Response to request for information – 20 Bay Road, Warrington (Council Ref: LUC-2020-293)

Response to request for information (Transport) – 20 Bay Road, Warrington (Council Ref: LUC-2020-293)

VEHICLE TRACKING
SHEET 1 OF 3

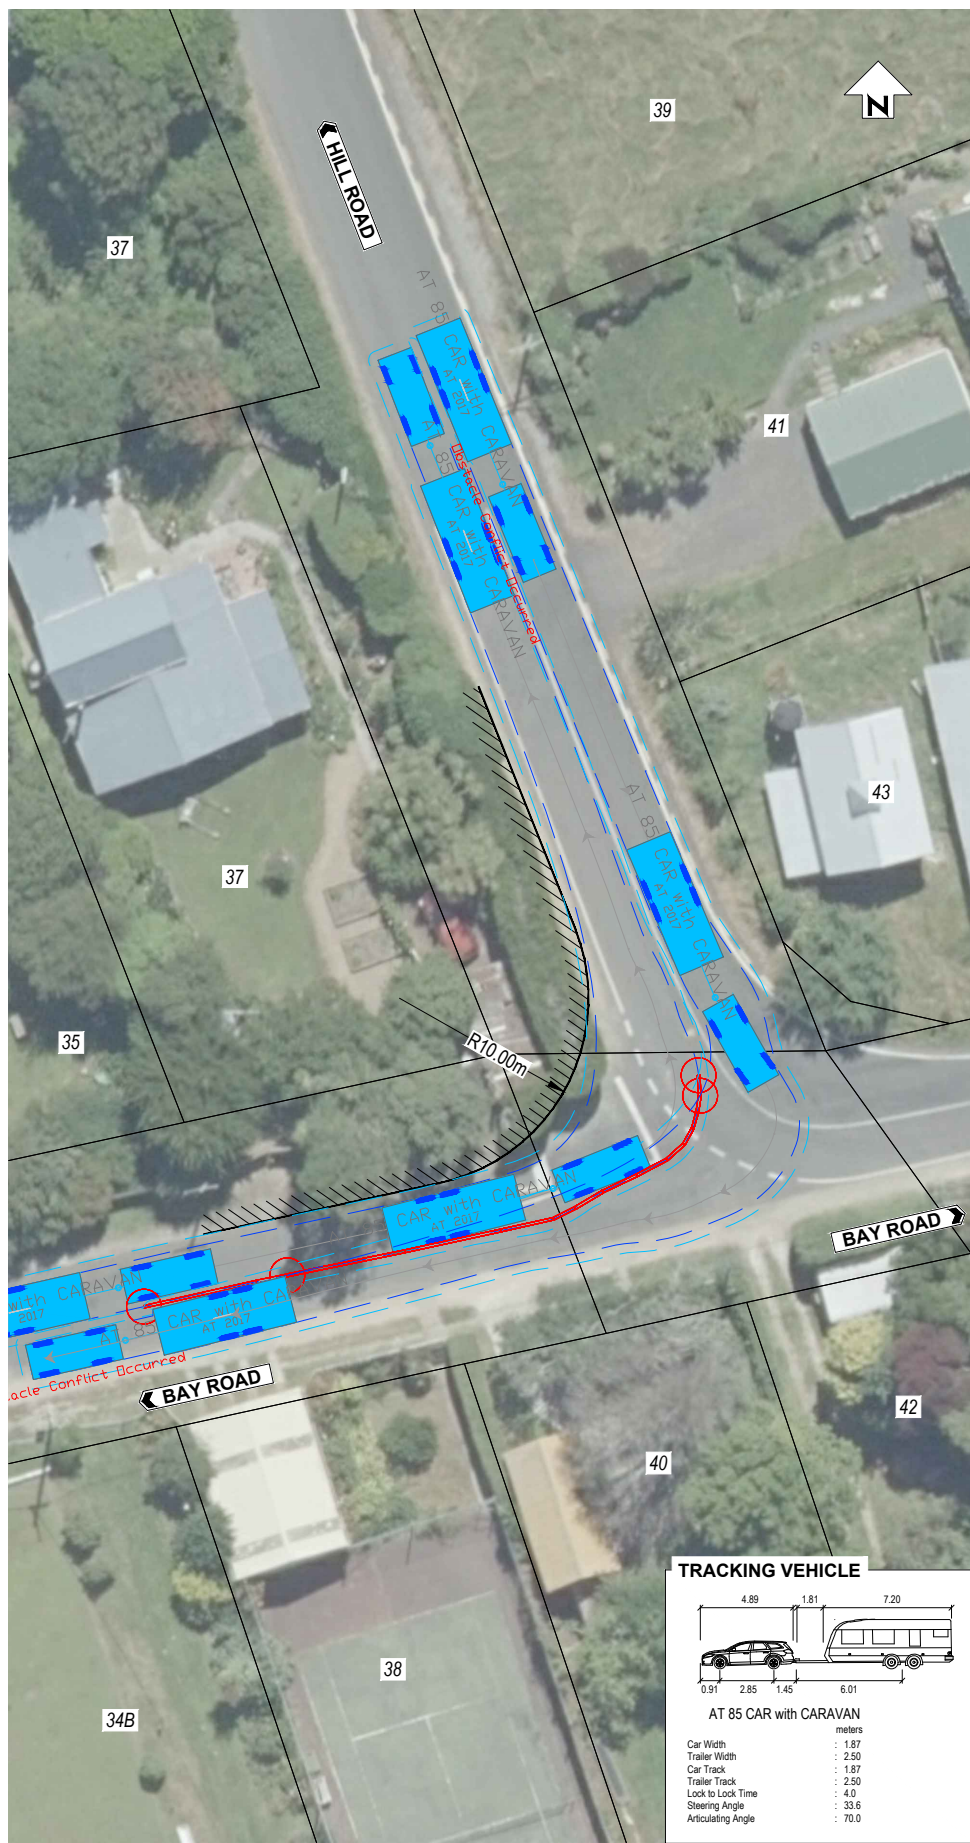
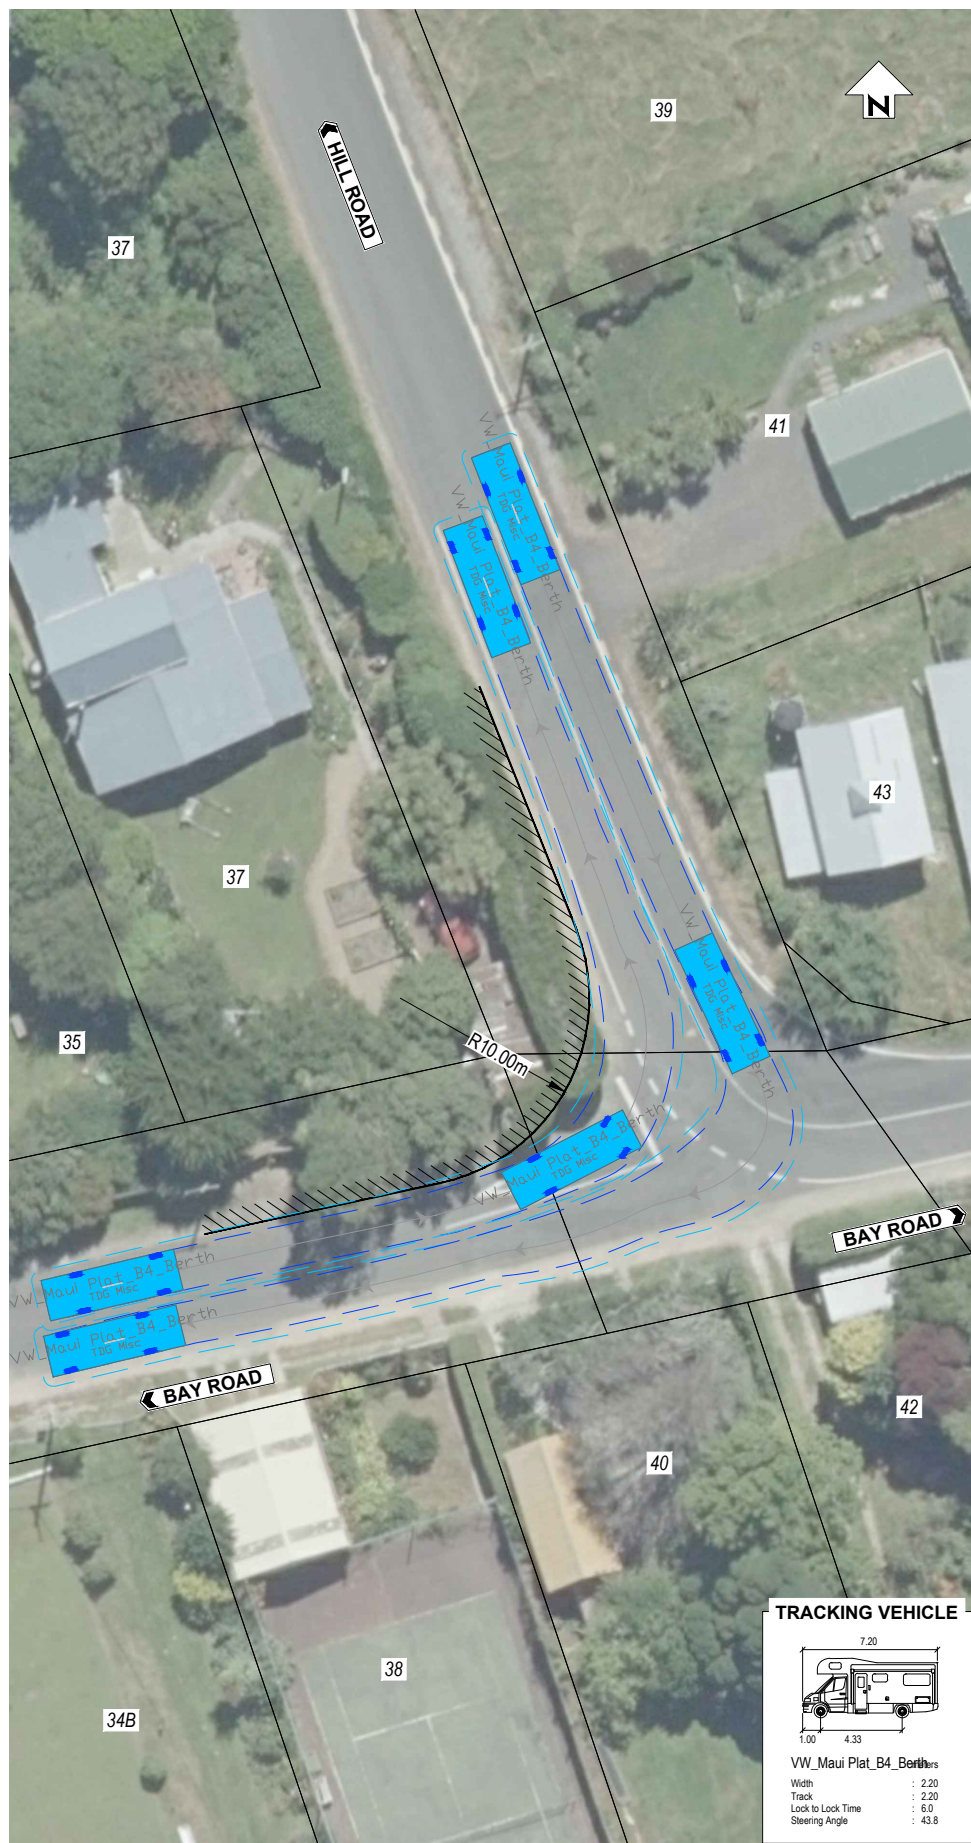
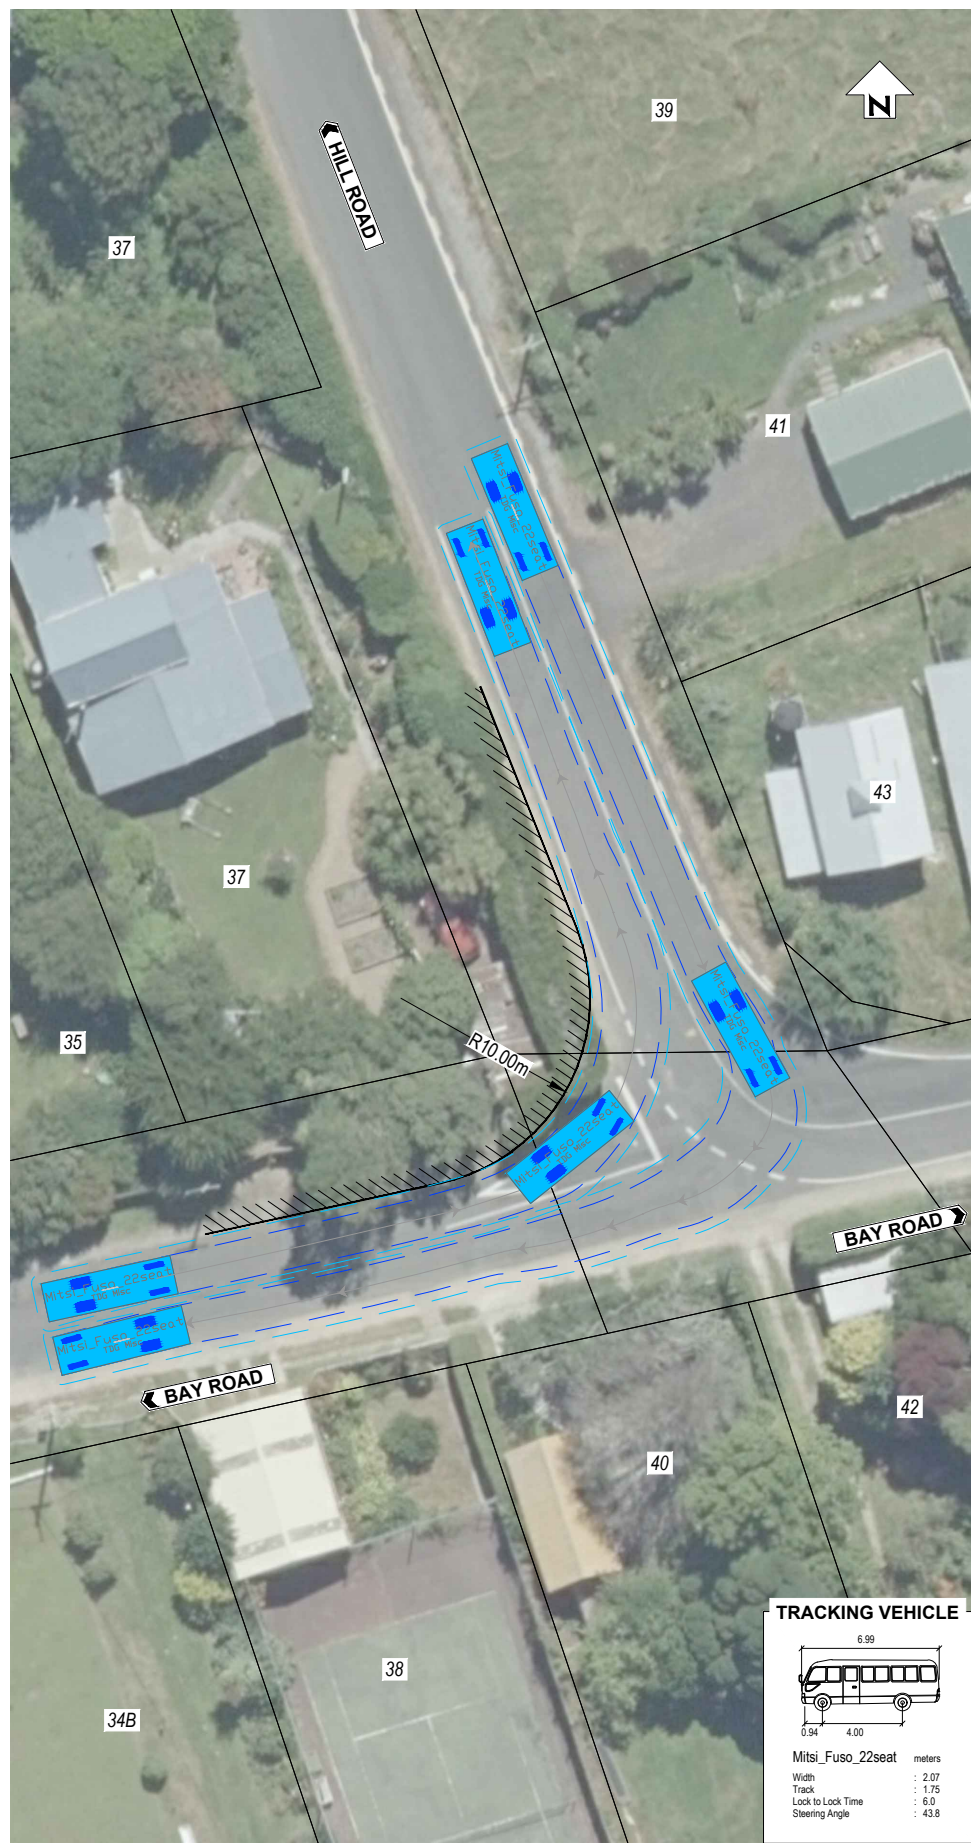
Vehicle tracking analysis has been undertaken with and without the widening of the intersection. This analysis demonstrates that large vehicles are able to safely negotiate the intersection in its current form without improvements being made, but that widening the intersection would ensure that two-way movement of large vehicles would be possible. In practice, the anticipated low volume of movements generated by the proposed NZMCA camping ground and the generally tidal nature of the traffic flows means that the potential for conflict will be very low.

20 BAY ROAD, WARRINGTON
ACCESS & SITE
VEHICLE TRACKING
SHEET 3 OF 3

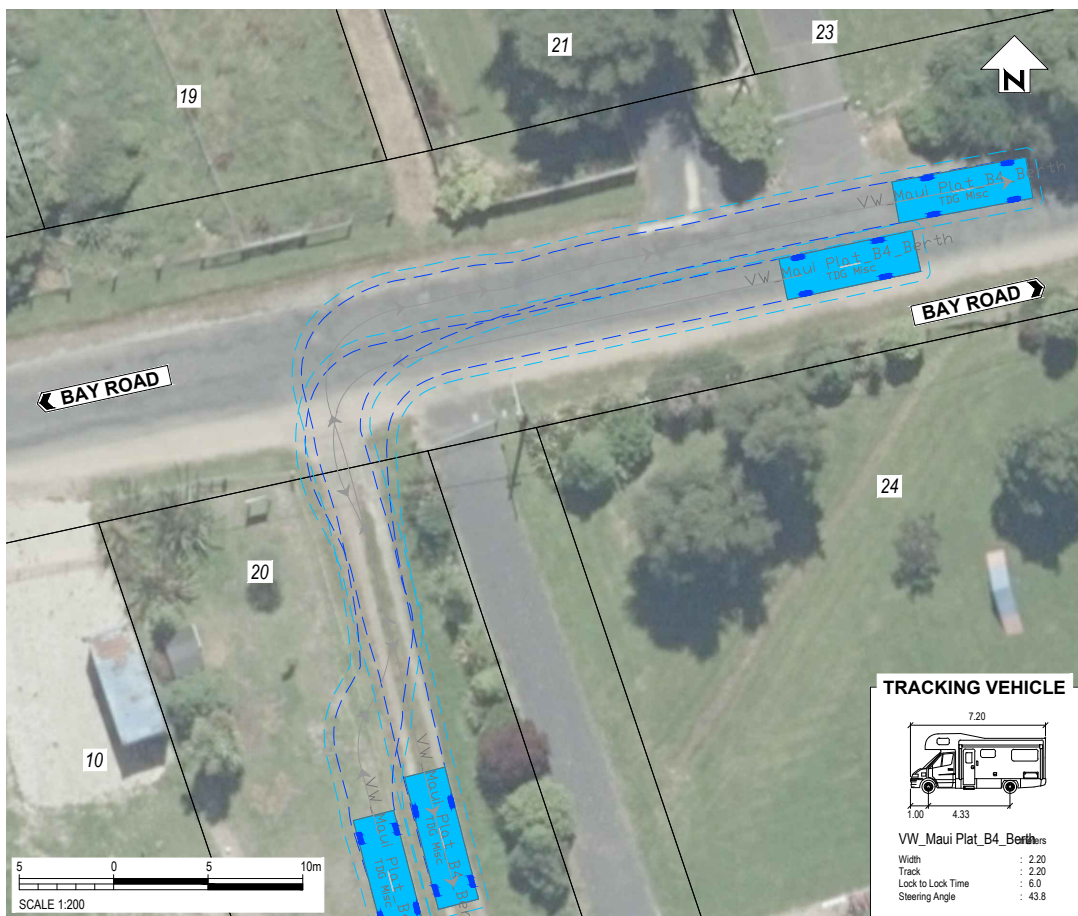
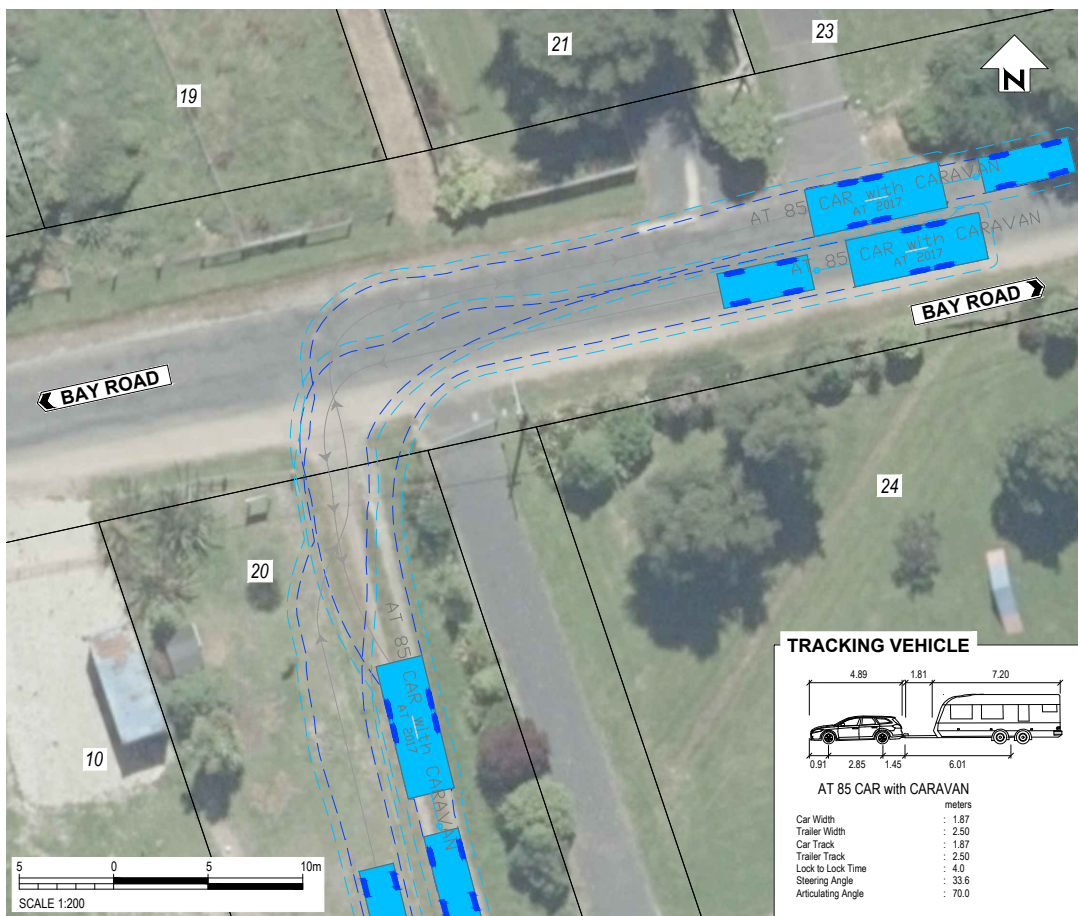
The camping ground has been set out to provide individual sites that are 6 m wide and 13 m deep which is sufficient to accommodate all vehicle types anticipated while still providing separation from adjacent vehicles.

The central access aisle is 20 m wide which is adequate to accommodate all anticipated manoeuvres associated with parking vehicles.
